RIJAN OIL COMPANY, INC.
20 FIRST PLAZA, SUITE 402
ALBUQUERQUE, NEW MEXICO 87102
(505) 243-0665

This is an Addendum to the "Application for Permit to Drill, Deepen, or Plug Back" on the Rijan Oil Company, Inc. well # Federal 3-26, Section 26, Township 19 North, Range 3 West, Sandoval County, New Mexico.

APPLICATION FOR PERMIT TO DRILL, DEEPEN, OR PLUG BACK

Shaffer Type SL BOP Specifications:

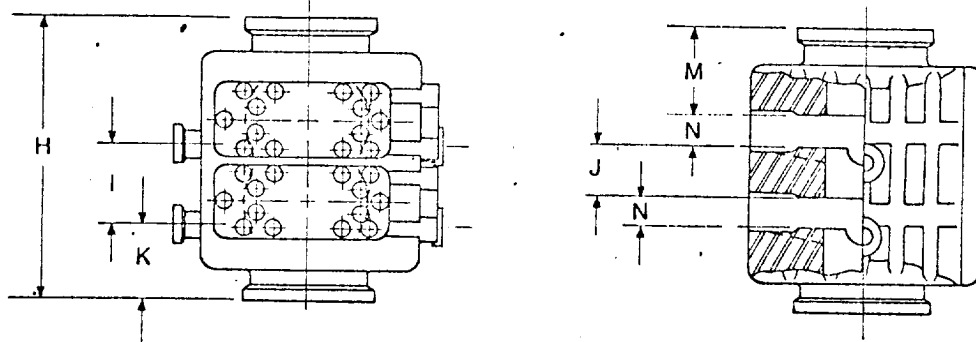
A schematic diagram of the blowout preventor to be used on this well with pressure rating and size is attached.

10" Shaffer Type SL BOP with Hydraulic closing system.

Working pressure	3000 psig.
Piston size	10 inches
Dimensions in inches:	
Length(L)	130
(F)	41
(G)	68
Width(W)	40
Height(H)	36
(K)	10
(M)	6 3/8
(N)	4 1/2
(O)	21 3/4
(P)	21 3/4
